HISTORIC AND DESIGN REVIEW COMMISSION

HDRC CASE NO: 2017-282
ADDRESS: 135 E COMMERCE ST
LEGAL DESCRIPTION: NCB 106 BLK LOT 35 (WITTE BUILDING I SUBD)
ZONING: D, HE, RIO-3
CITY COUNCIL DIST.: 1
LANDMARK: Witte Building
APPLICANT: Andrew Douglas/Douglas Architects
OWNER: 135 E Commerce LLC
TYPE OF WORK: Construction of an elevator tower addition
REQUEST:

WITTE BUILDING

HISTORIC DESIGN REVIEW COMMITTEE PRESENTATION

PROPOSED WEST ELEVATION - STONE CLADDING SYSTEM

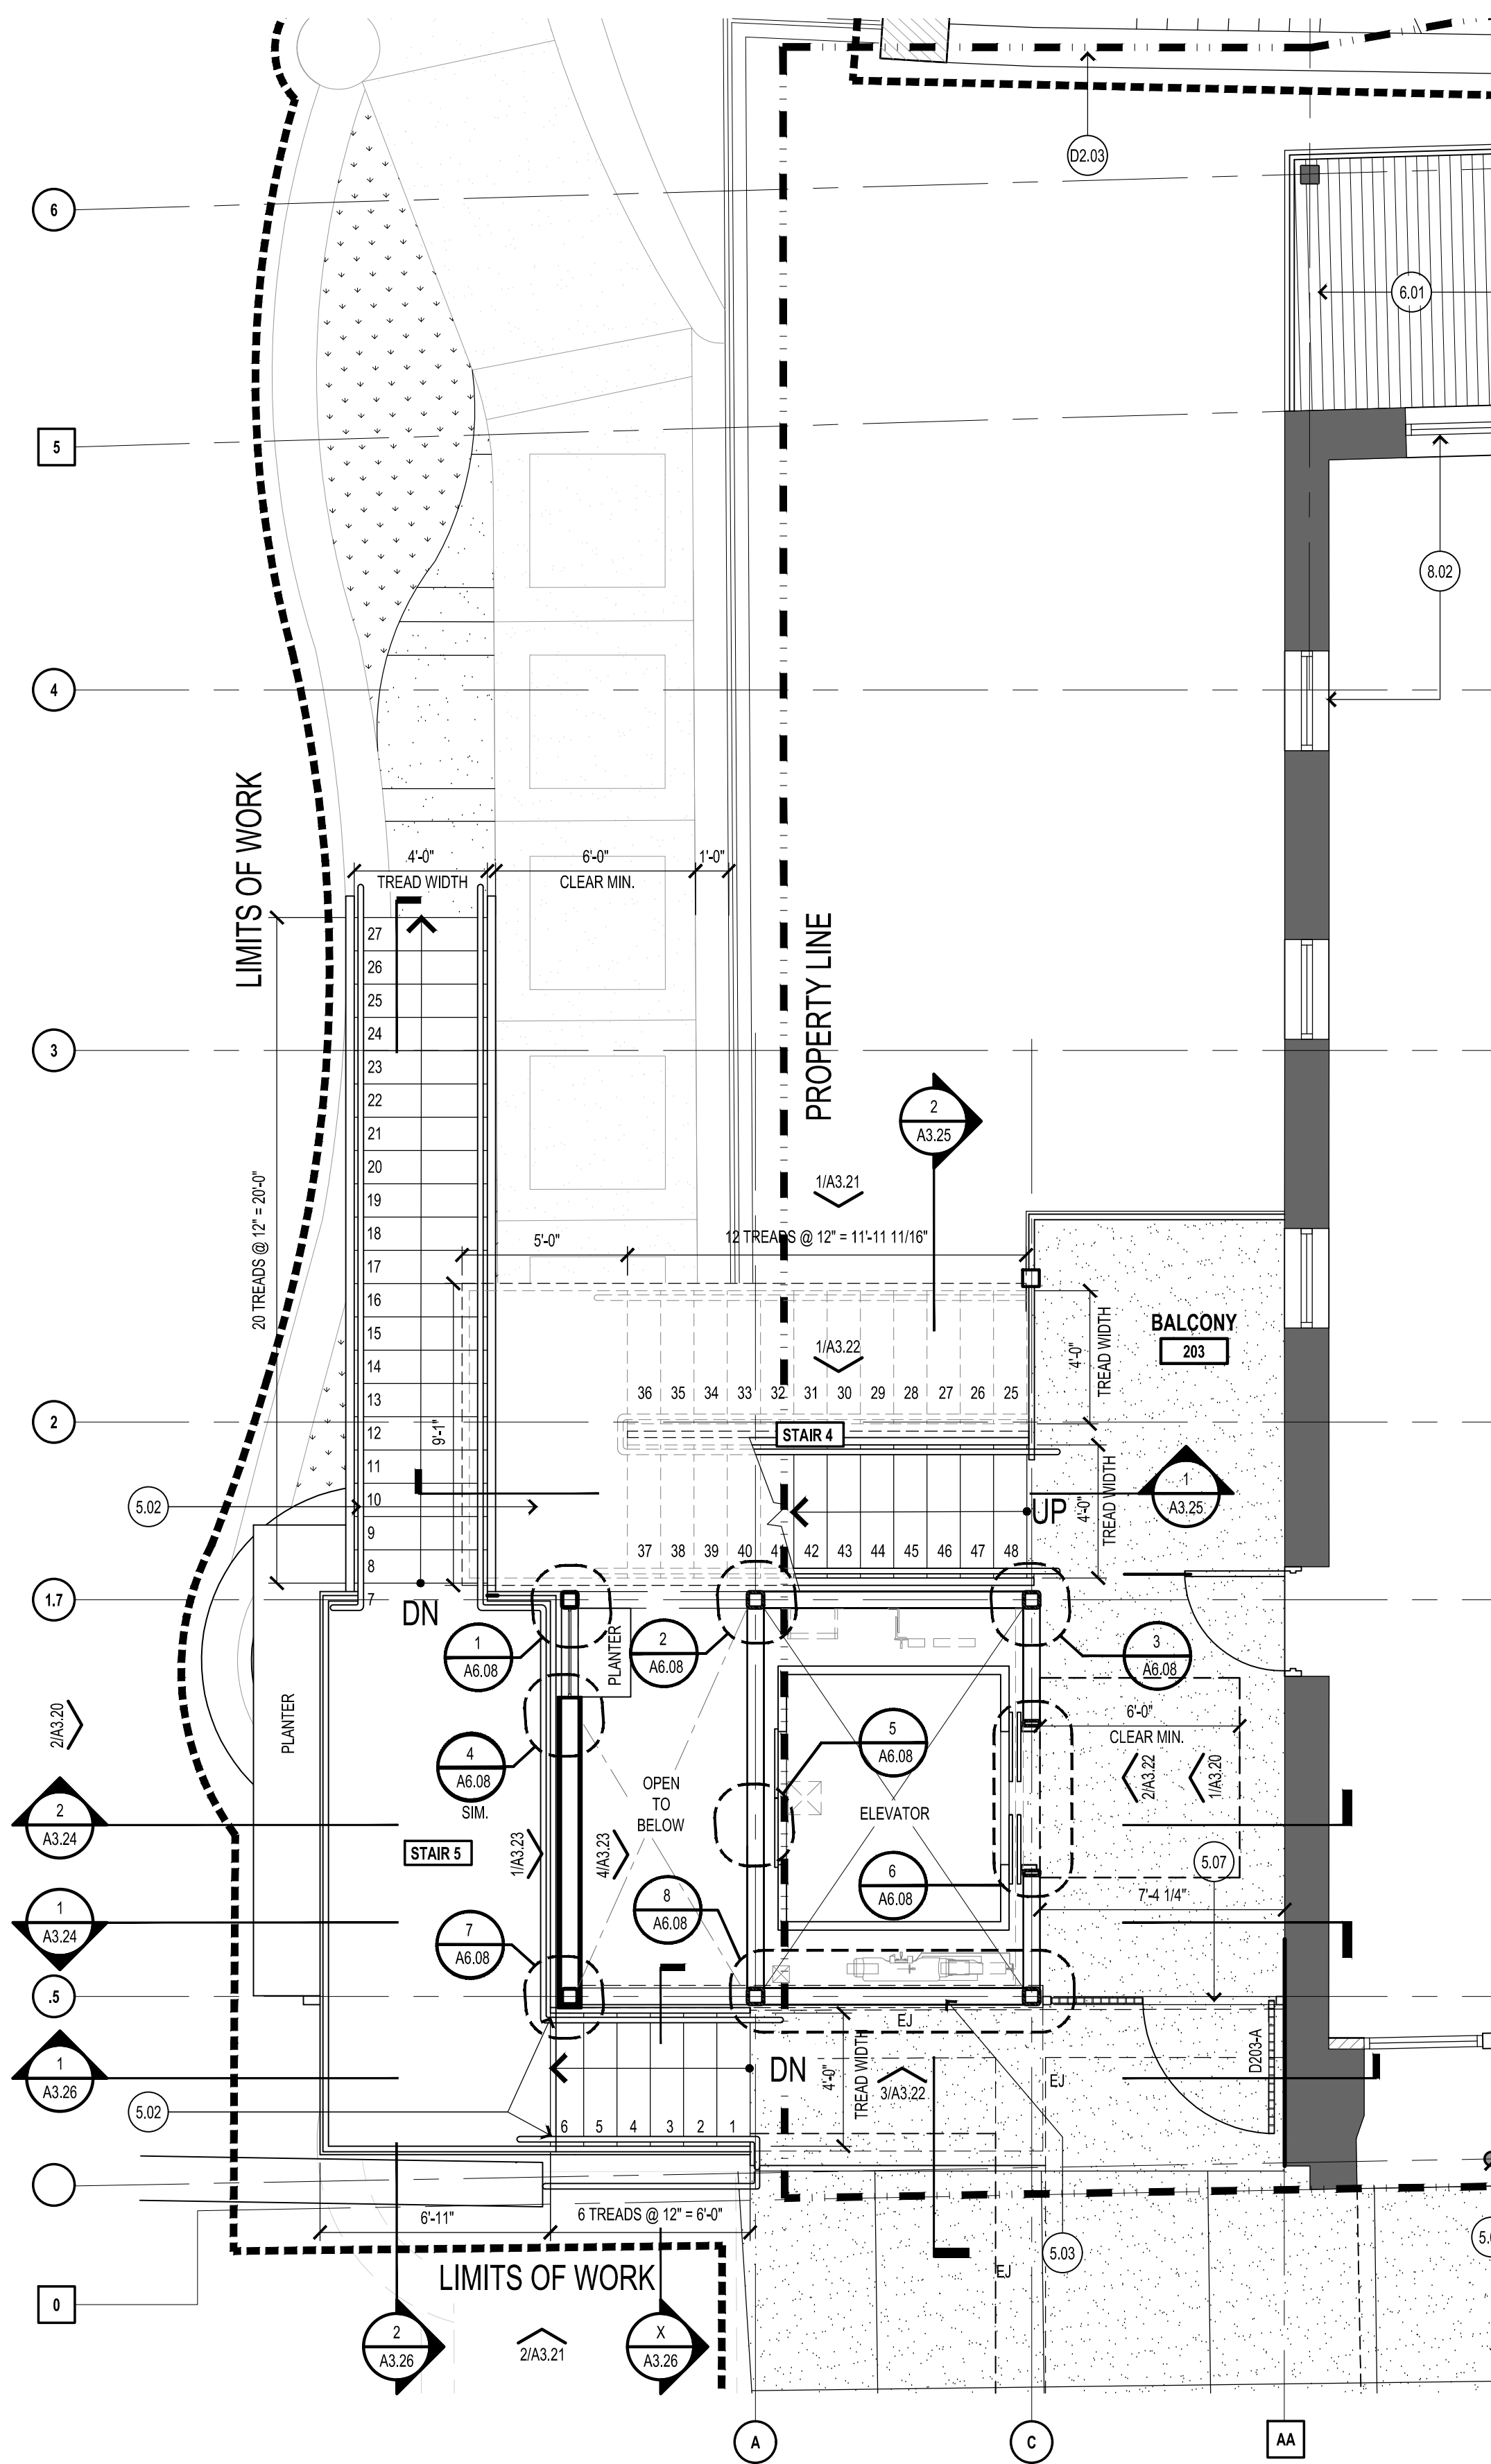
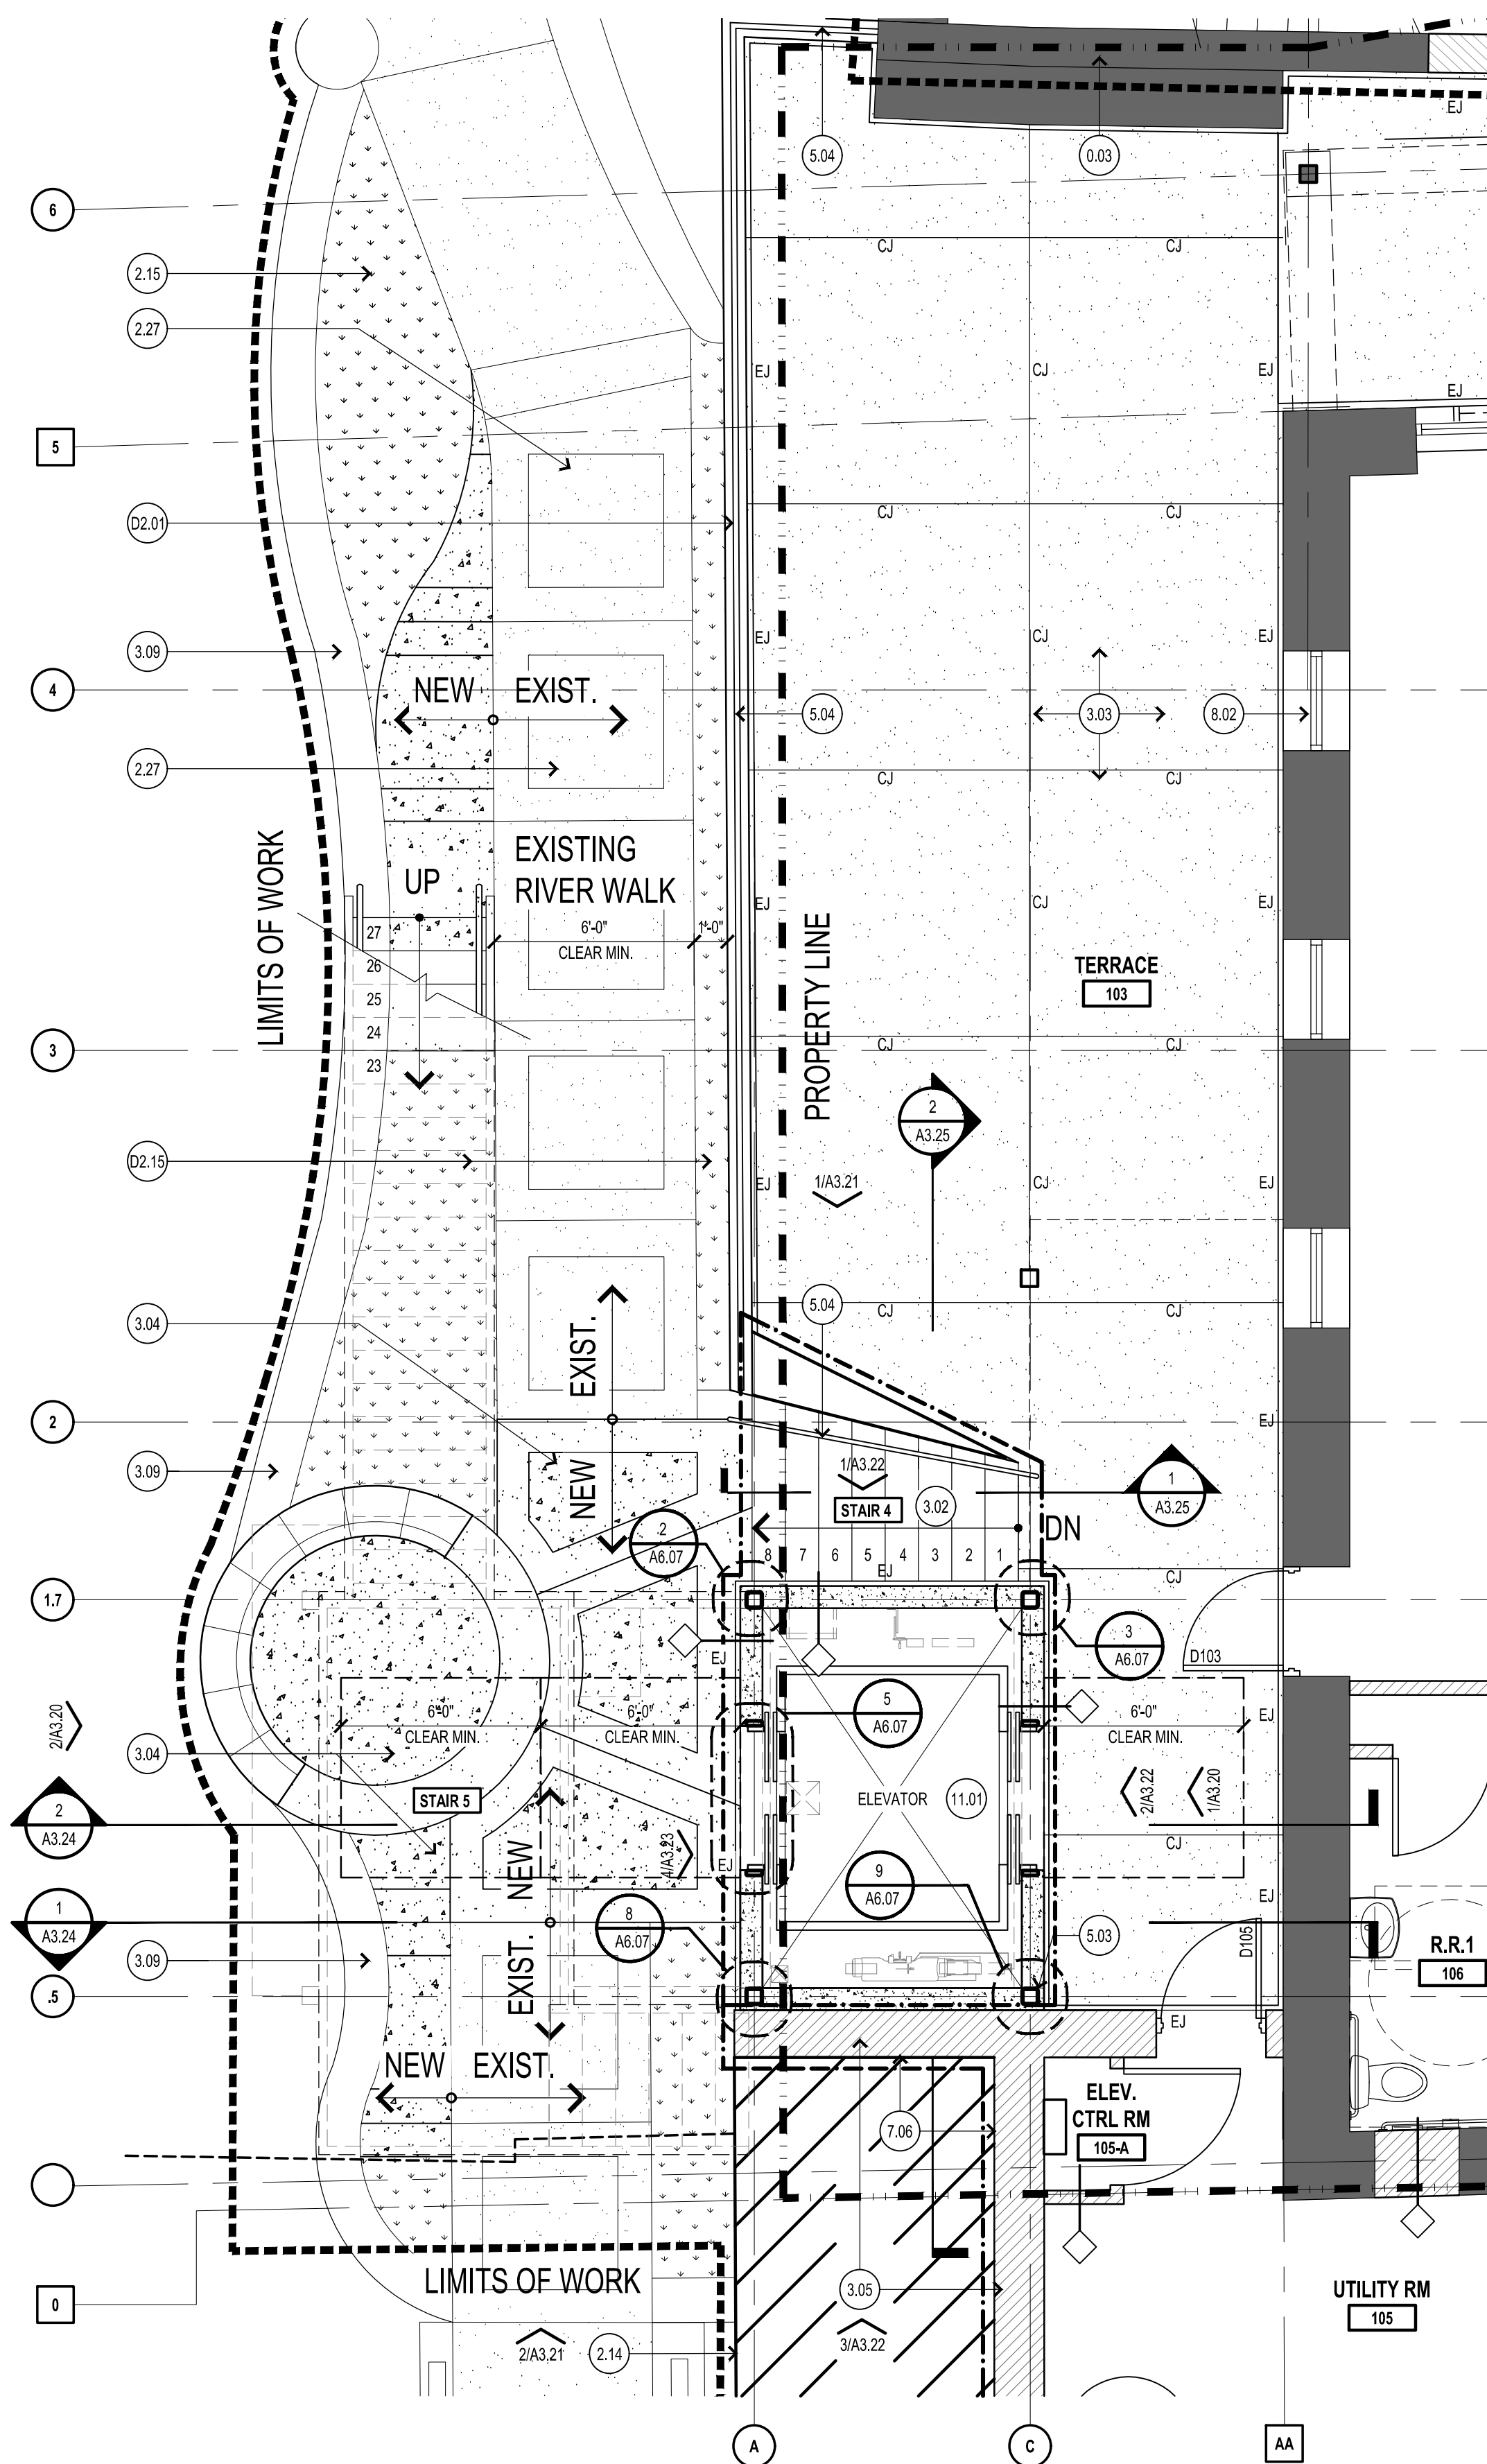
- h. **ELEVATOR CLADDING** – In order to provide a cladding material that relates to the exterior materials of the Witte Building, the applicant has proposed the addition of cast-stone cladding with limited glass fenestrations per recommendation by the THC. With the additional cladding, the elevator now obstructs views of the Witte

Building and is more visually massive on the street. Staff finds that the previous exposed steel frame allowed for greater transparency and a lighter appearance. According to the historic design guidelines, new additions should be visually subordinate to the historic building and distinguishable as a contemporary element without distracting from the original structure. Staff does not find that the currently-proposed elevator is successful in this aspect. The applicant, in consultation with the THC, should explore additional options which increase the amount of fenestration and overall transparency and reduce the visual impact of the masonry cladding system. For example, portions of masonry could be grouped at the street and river levels with a more open and transparent structure at the 2nd and 3rd levels to preserve views of the Witte Building. Furthermore, while staff understands that the addition of a masonry component may result in an improved relationship between the elevator and the Witte Building, the proposed cast stone introduces a new material that is not currently found in the Witte Building. The addition of brick as a masonry component would be more consistent with the materials found in the Witte Building and would be more appropriate.

- j. **ELEVATOR TOWER HEIGHT** – The applicant has proposed to construct the elevator tower addition to be less than the height of the primary historic structure, the Witte Building. Originally, the proposed elevator tower was to feature a reduced height as to not obscure historic window openings on the west façade of the Witte Building; however, it has since been increased in height and was conceptually approved at this increased height. At its current height of thirty-three (33) feet, staff the elevator tower appropriate; however, staff has concerns regarding the visual weight massing that will be exposed with the newly proposed stone cladding system.

Staff does not recommend approval at this time. Staff recommends that the proposed masonry cladding system of the elevator be greatly reduced in order to maintain a predominately transparent appearance. Staff also recommends that a more compatible masonry component, such as brick, be explored. Staff supports the applicant's efforts and will work diligently with the THC to reach a design solution that is respectful of this sensitive location and maintains project's

TITLE: INTERLOCKING CHANNEL ATTACH SYSTEM

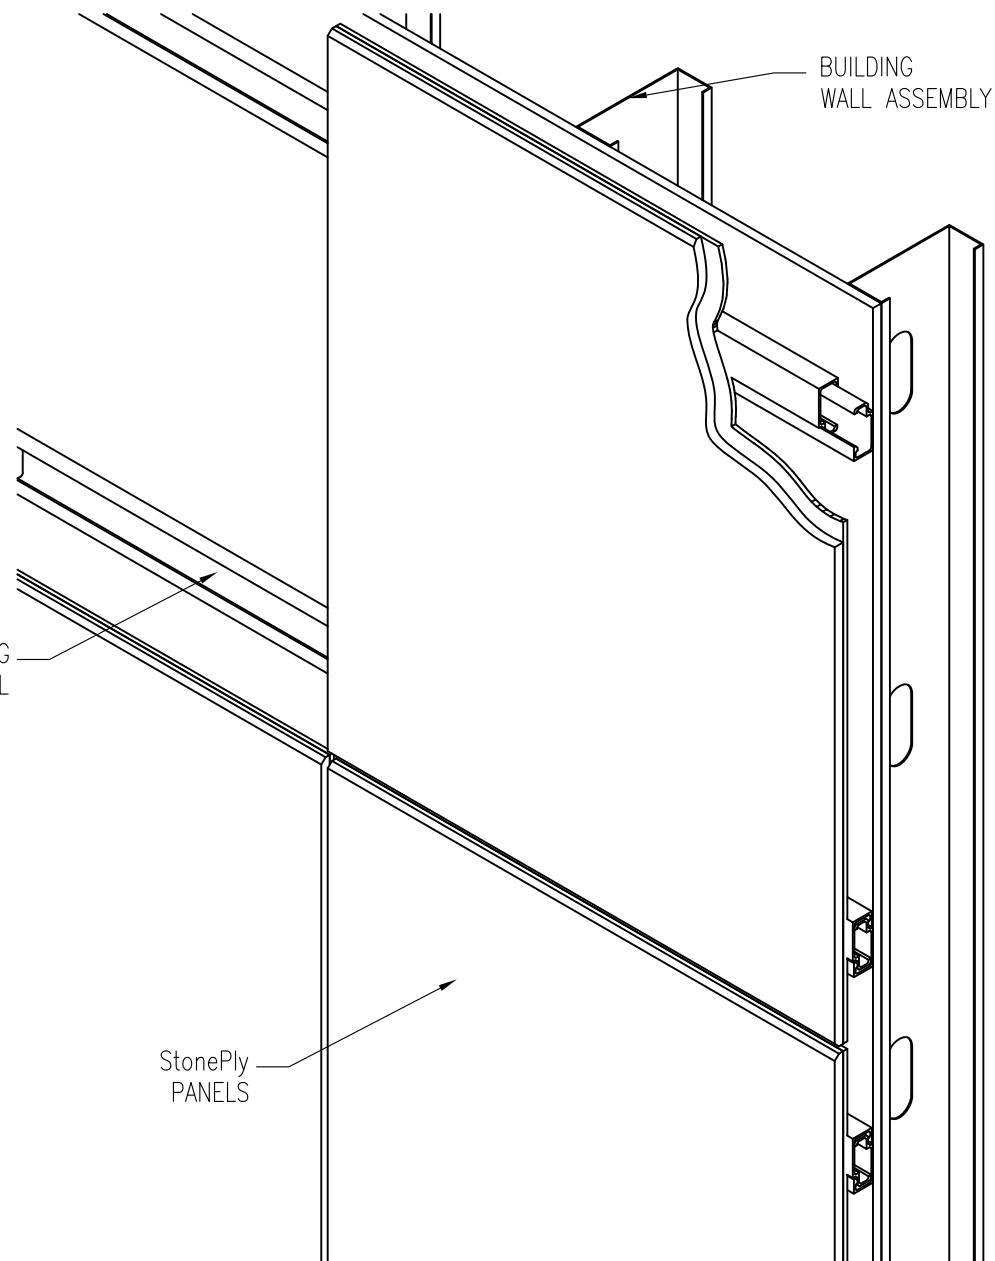
COMMENTS/CONCERNS: MG! QUESTIONS REGARDING THE PROPOSE NEW
MASONRY CLADDING MATERIAL - CLARIFICATION NEEDED. IS! PROPOSAL
INCLUDES A LIMESTONE CLADDING. MG! PROPOSED REDSIGN IS
APPROPRIATE AND ELEGANT IN DESIGN.
